Access Compliance Report
Public Rights-of-Way
(Curb Ramps)

Intersection ID: 7001	**Main Street: MCALLISTER_DR**	**Cross Street: CRICKETEER_DR**	**Location: SE**
ADA ID: 56676EFE2468	**Ramp Type: Perp**	**Initial Pass/Fail: Fail**	**Overall Compliance: No** / **Severity Score: 37.5**

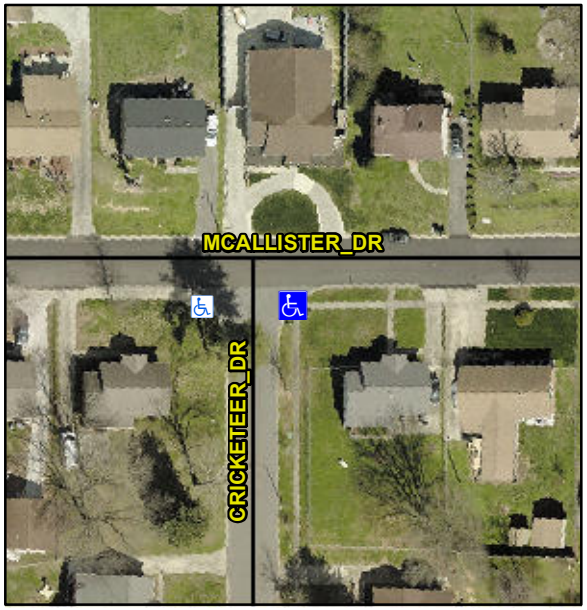
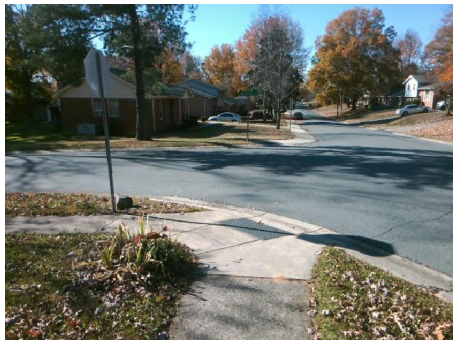
Not Found, R304.2.2, R304.5.3

Compliance	Description	Data	Compliance	Description	Data
N/A	Ramp Length (in)	25.0	No	Ramp Slope (%)	9.3
Yes	Ramp Width (in)	48.0	No	Ramp XSlope (%)	9.2
N/A	Flare Type LT	N/A	N/A	Flare Type RT	N/A
N/A	Flare Slope LT (%)	N/A	N/A	Flare Slope RT (%)	N/A
N/A	Flare Traversable LT?	N/A	N/A	Flare Traversable RT?	N/A
N/A	Landing Length (in)	N/A	N/A	DWS Provided?	N/A
N/A	Landing Width (in)	N/A	N/A	DWS Contrast?	N/A
N/A	Landing Slope (%)	N/A	N/A	DWS Length (in)	N/A
N/A	Landing X Slope (%)	N/A	N/A	DWS Full Width?	N/A
N/A	Landing Curb? (Y/N)	N/A	N/A	DWS Offset (in)	N/A
N/A	Shared Landing?	N/A			
N/A	Gutter Ponding?	N/A	N/A	Gutter Slope (%)	N/A
N/A	Gutter Lip Ht (in)	N/A	N/A	Gutter X Slope (%)	N/A
N/A	Painted X Walk1?	No	N/A	Painted X Walk2?	N/A
	X Walk 1 Direction	To W		X Walk 2 Direction	N/A
N/A	X Walk 1 Width (in)	N/A	N/A	X Walk 2 Width (in)	N/A
	X Walk 1 Slope (%)	1.8		X Walk 2 Slope (%)	N/A

Remove & Replace Entire Ramp.
